AGENDA
PLANNING AND ZONING COMMISSION MEETING
CITY OF CREVE COEUR, MISSOURI
MONDAY, MARCH 16, 2015
7:00 PM

APPLICATION TO PLANNING AND ZONING COMMISSION #15-001 FOR SITE DEVELOPMENT PLAN OF AN OFFICE BUILDING AT 844 N. NEW BALLAS COURT

REQUEST: An application has been submitted for a new 16,467 sq. ft., three-story office building at the southeast corner of East Rue De La Banque and North New Ballas Court. The Applicants are seeking a site coverage bonus for the proposed 69.3% site coverage by providing seating and landscaping. Changes since the prior Staff Report, include revising the building materials, angling the entrance to be more oriented toward the street, and providing two site plans with and without the vacation of the easement.

Landscape Plan
1" = 10'-0" 3-10-2015
This Landscape Plan is the exclusive property of Horstmann Brothers, LLC Landscape Services.
Any reproduction of this plan without expressed written permission from Horstmann Brothers, LLC Landscape Services is strictly prohibited.

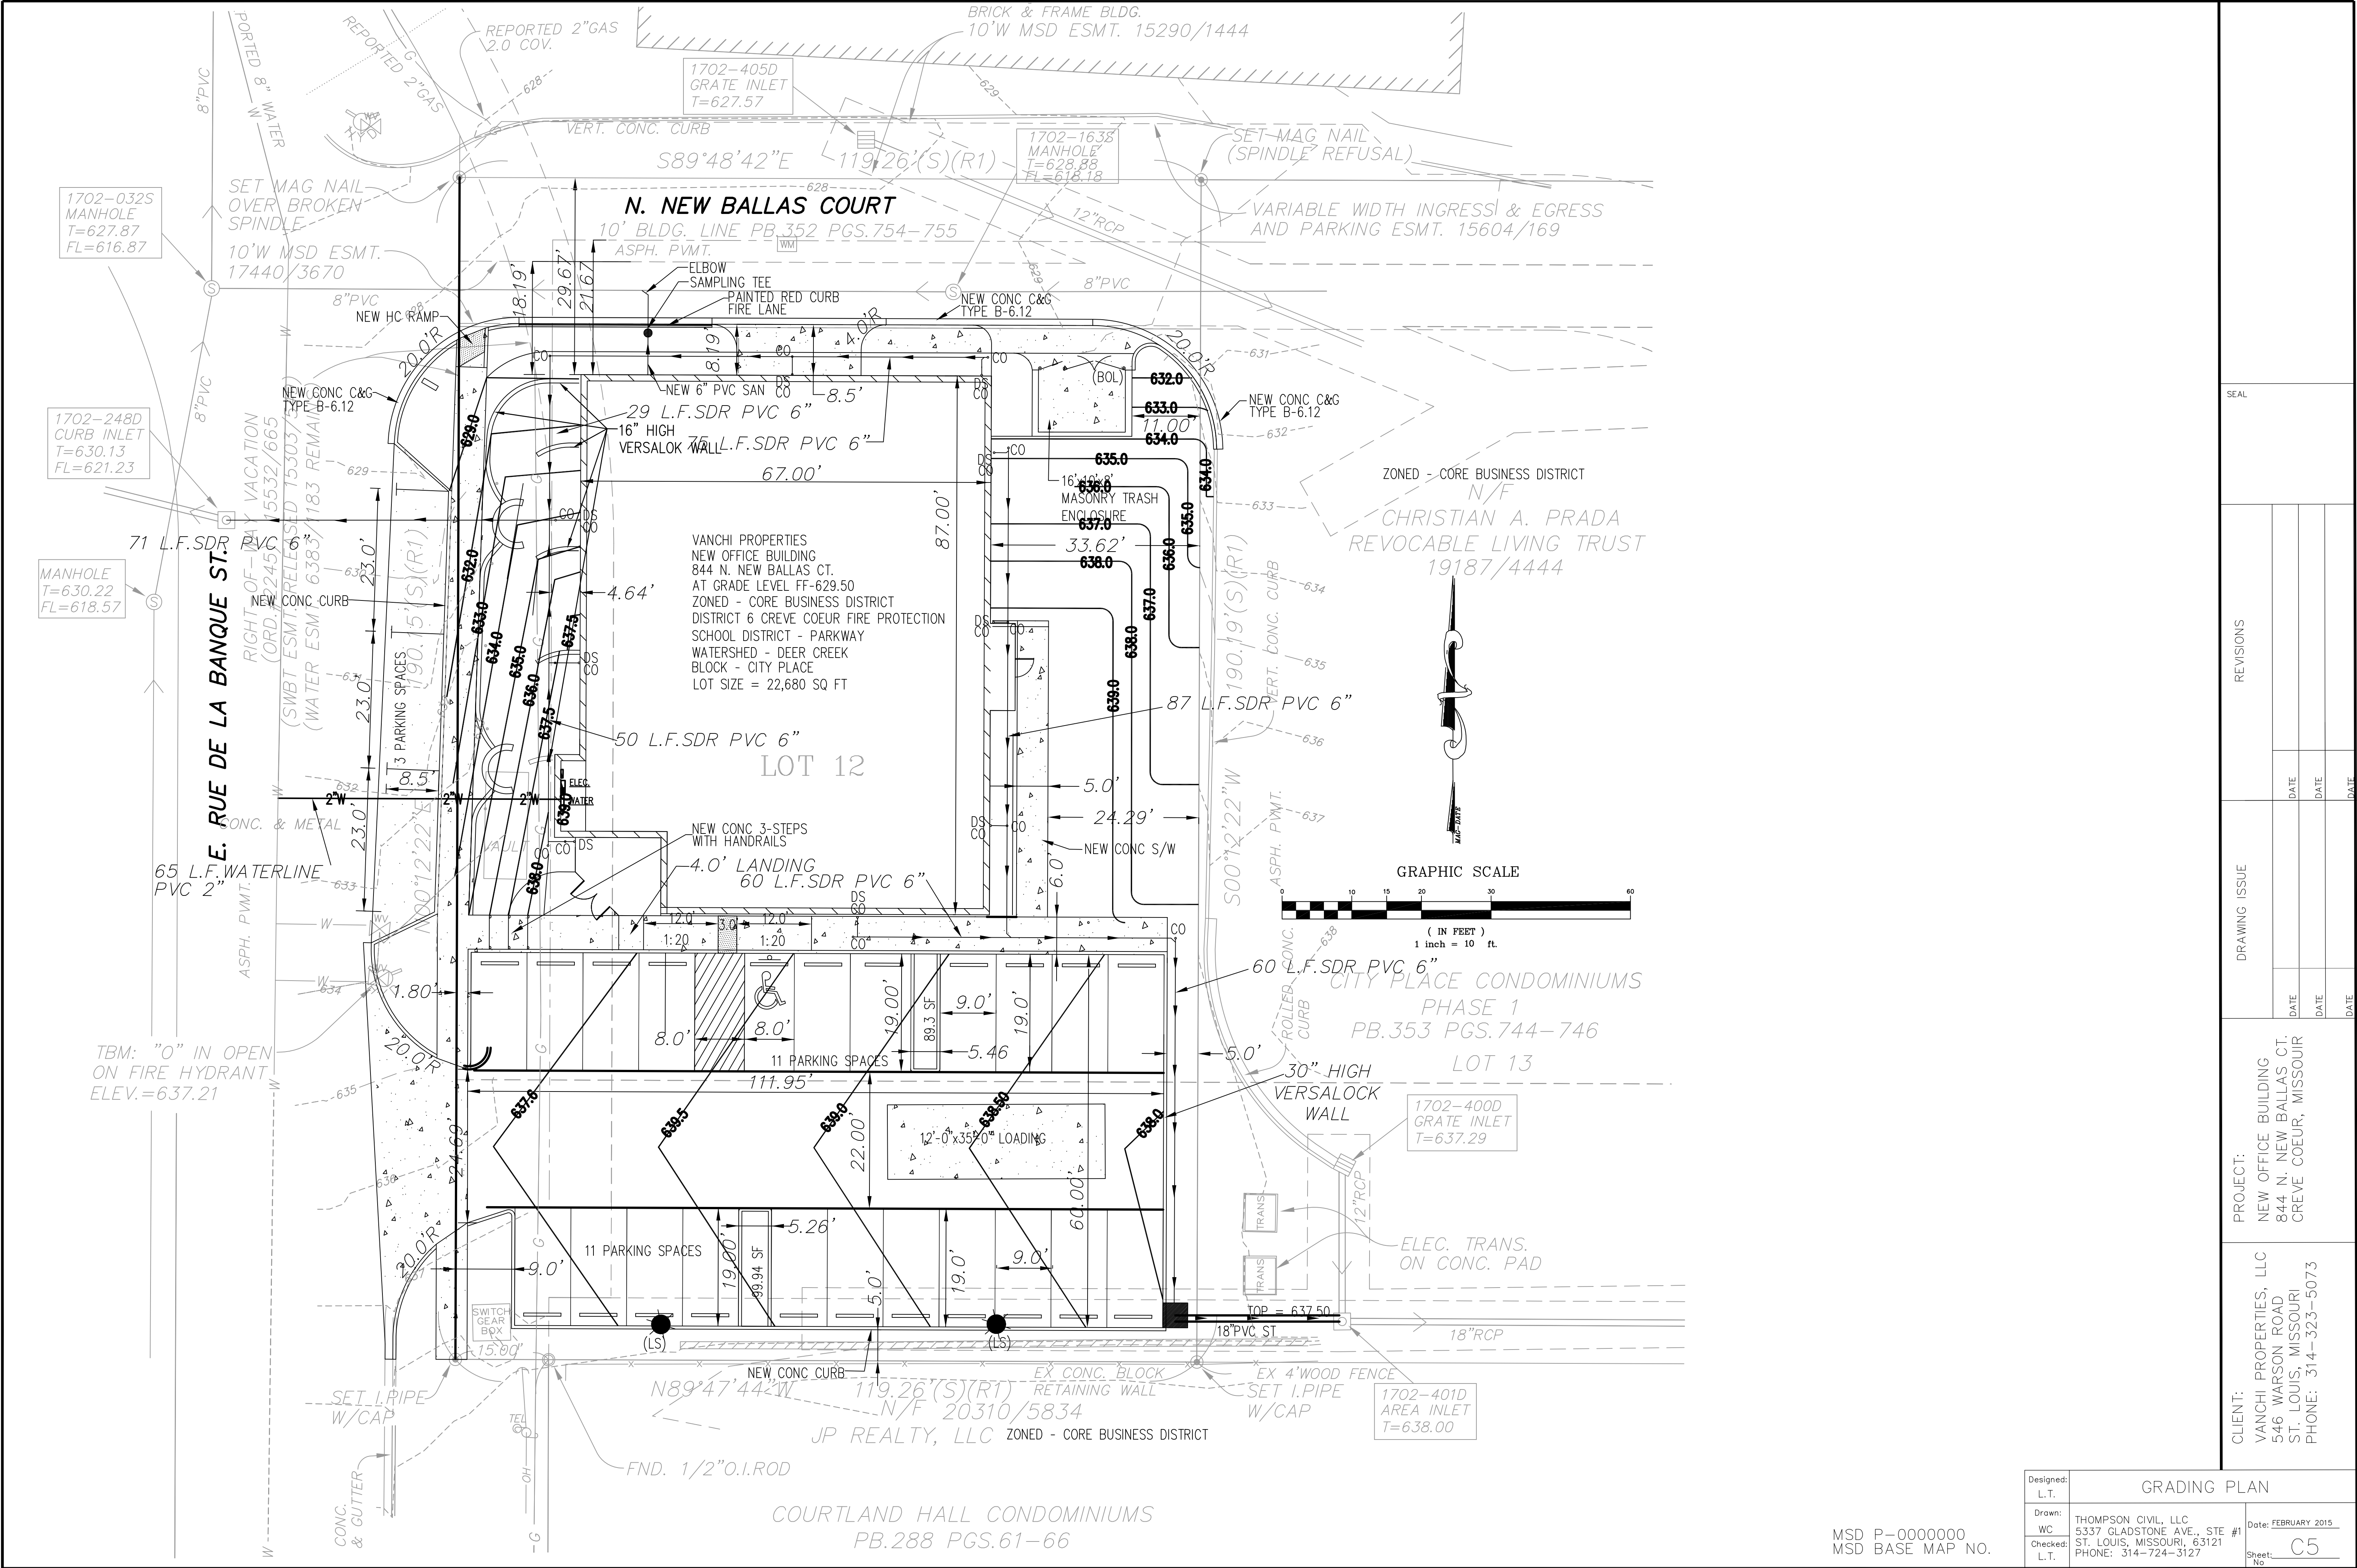
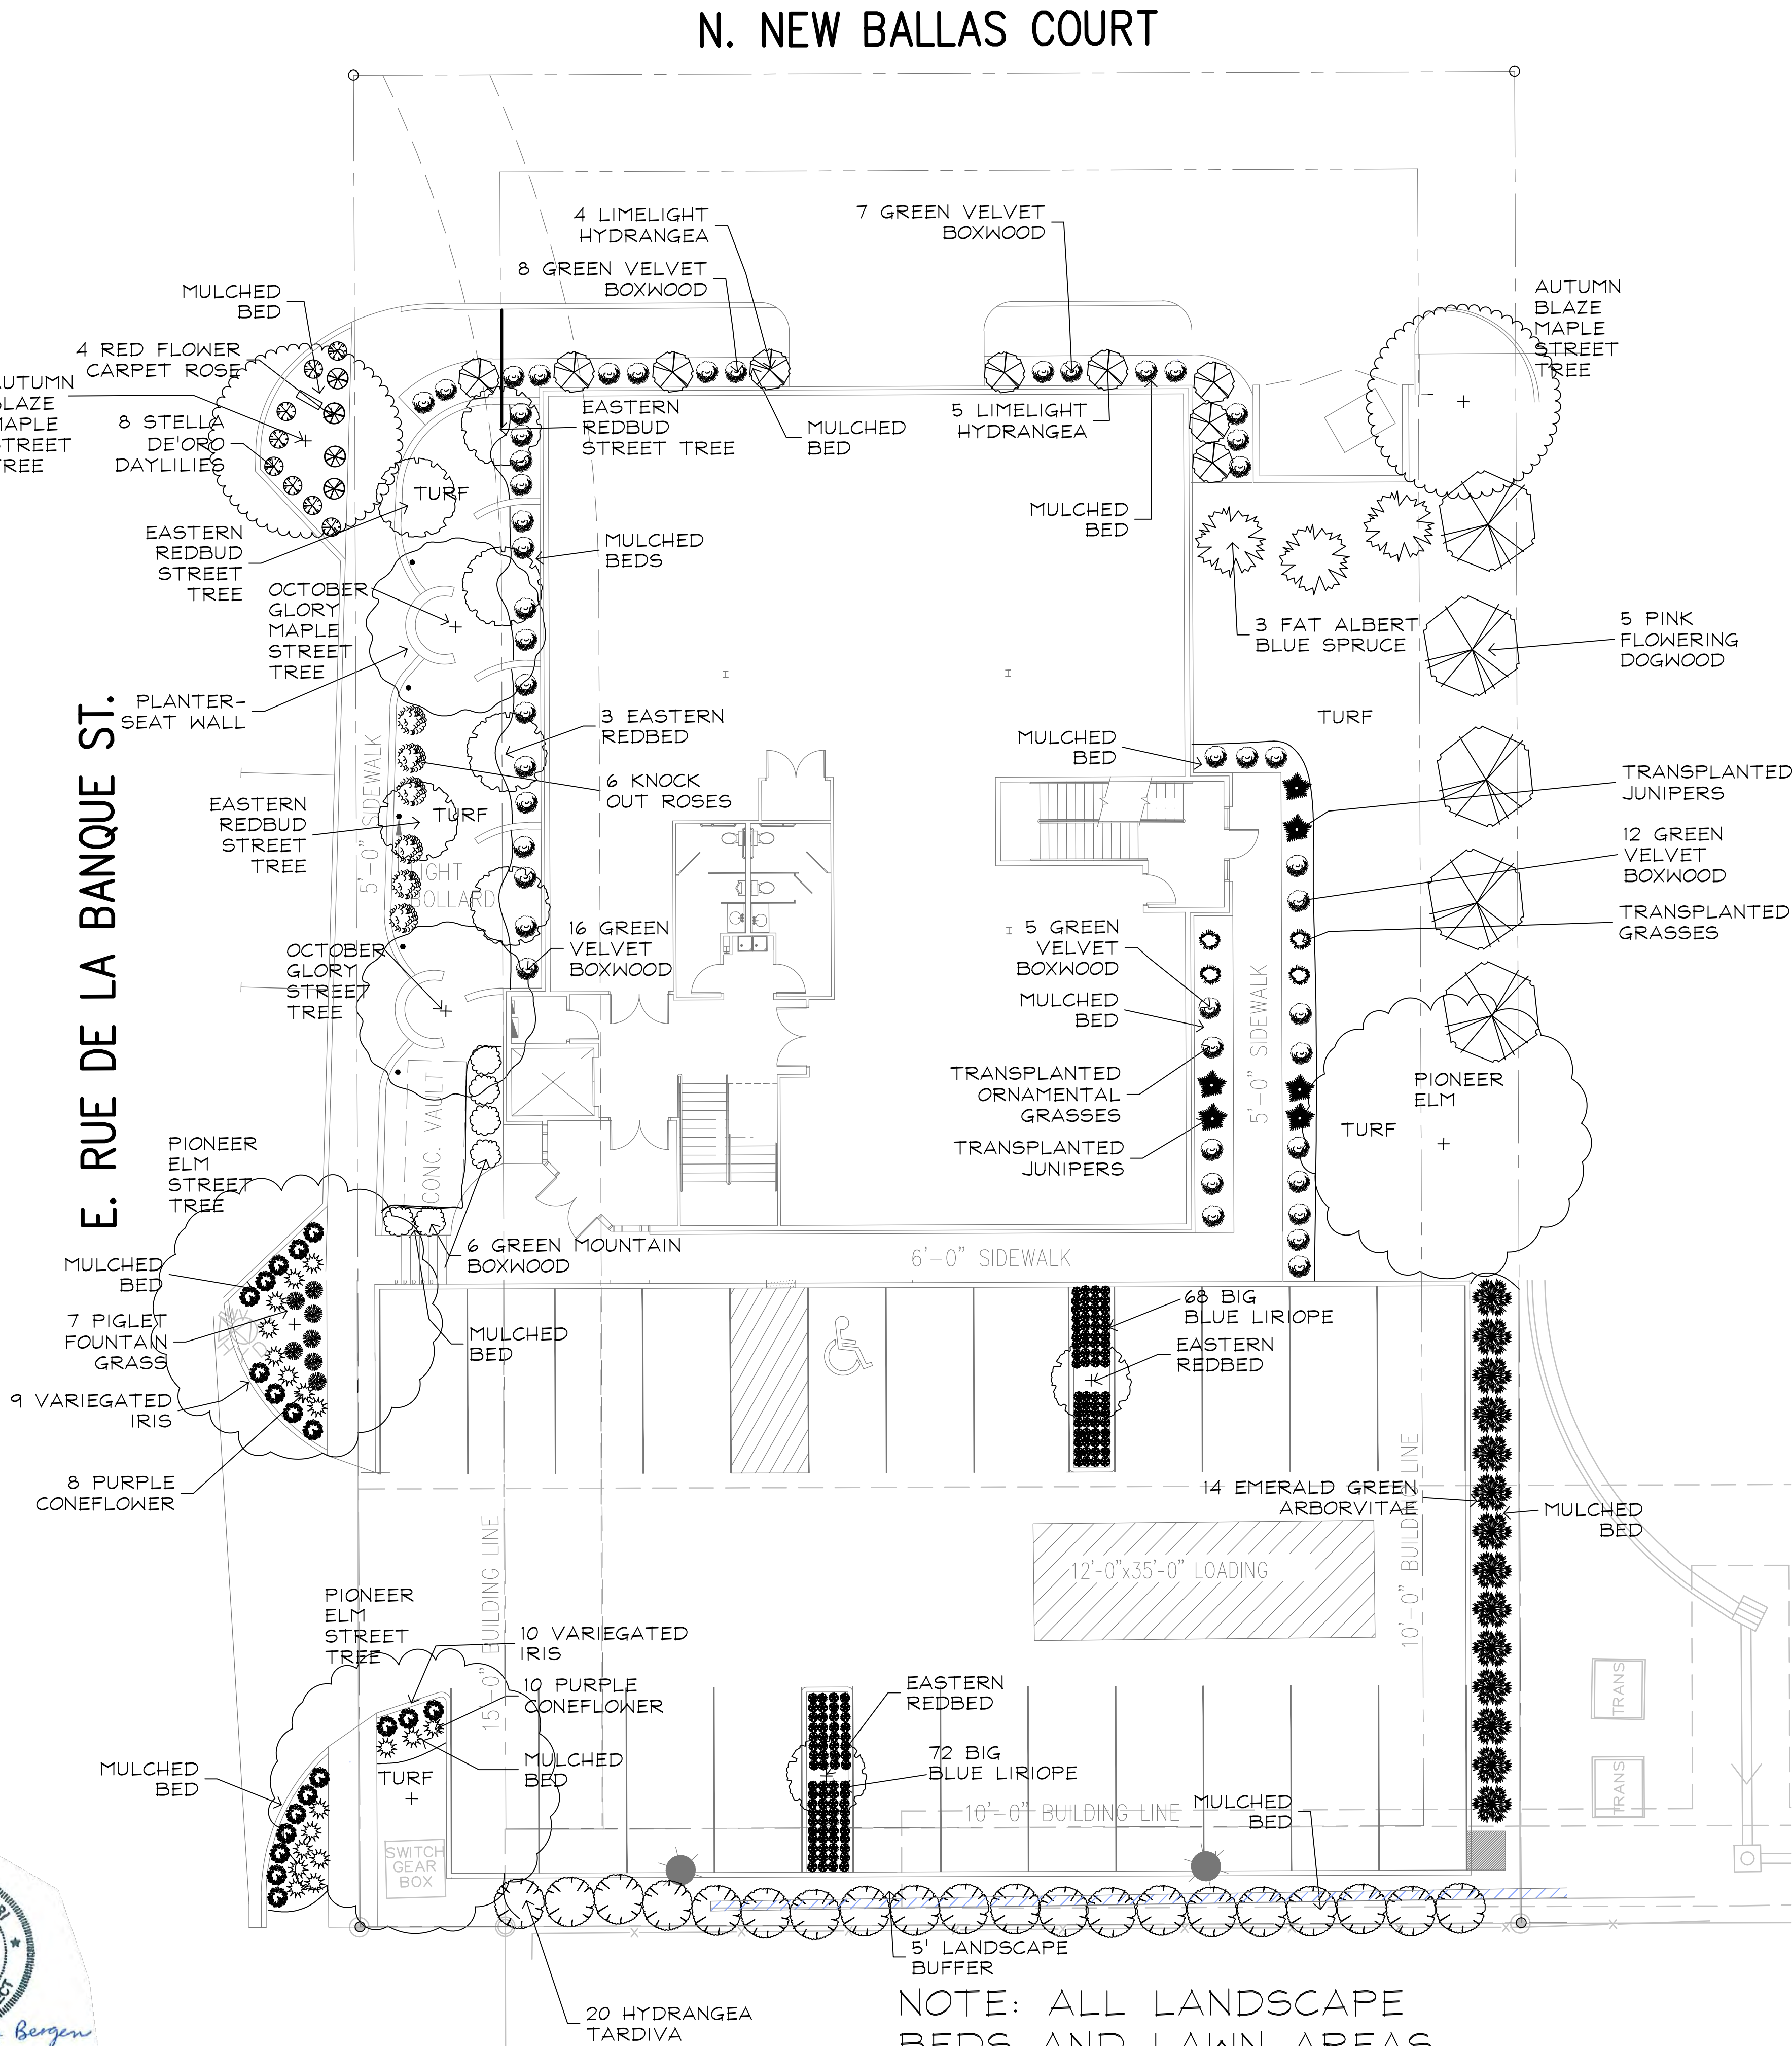
6. *Landscaping:* As discussed in the prior Staff Report, the Applicant's Landscape Plan meets with the minimum requirements regarding the number of street trees and screening of the parking lot. However, as discussed at the February 17th meeting, the addition of a low fence or wall would greatly improve the efficacy of the screen and should be considered by the Planning and Zoning Commission. Additional landscaping has been included within the parking lot, and terraced retaining walls next to the building. If the building is moved toward Rue de la Banque, it is unclear how the seating and the terraces work together, and seems unnecessary for both. A corrected grading plan, including tops and bottoms of all retaining walls will further clarify the design intent. A condition requiring revised drawings for the Zoning Administrators is recommended.

3. All drawings shall be corrected to a generally accepted drawing scale.
4. The Applicant shall amend the landscape plan to meet with the requirements of Section 405.540 Landscaping and 405.810(5) Screening and Landscaping of Article VII, Off-Street Parking and Loading Regulations, to provide an effective headlight screen in the form of a low fence or wall along the east line of the surface parking lot.
